# Charlotte Department of Transportation

## Memorandum

**Subject:** Rezoning Petition 15-016: Approximately 10.24 acres located on the northwest corner at the intersection of Bevington Place and Carswell Lane..

Figure 1

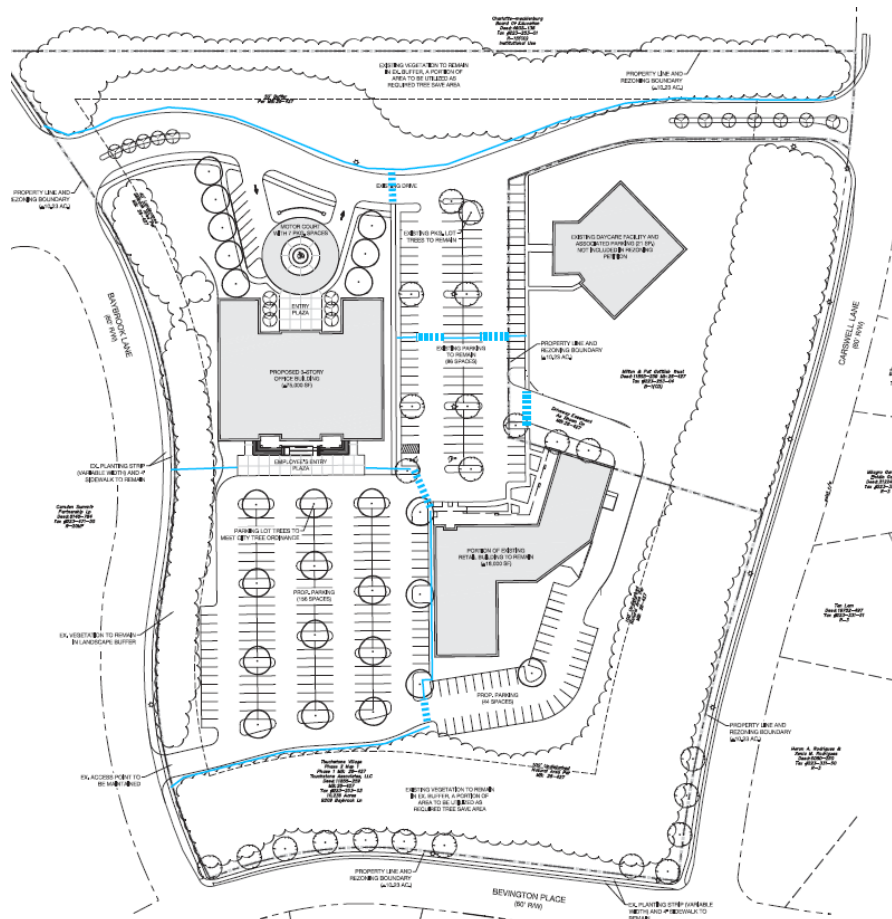
1. CDOT requests that the petition be revised to show sidewalk and internal crosswalks throughout the site. Please also provide a direct pedestrian connection from the proposed 3-story building to the sidewalk along Baybrook Lane (see Figure 1).
2. CDOT requests that the petitioner add sidewalk along the entire length of the existing driveway on the north portion of the site, from Baybrook Lane to Carswell Lane (see Figure 1).
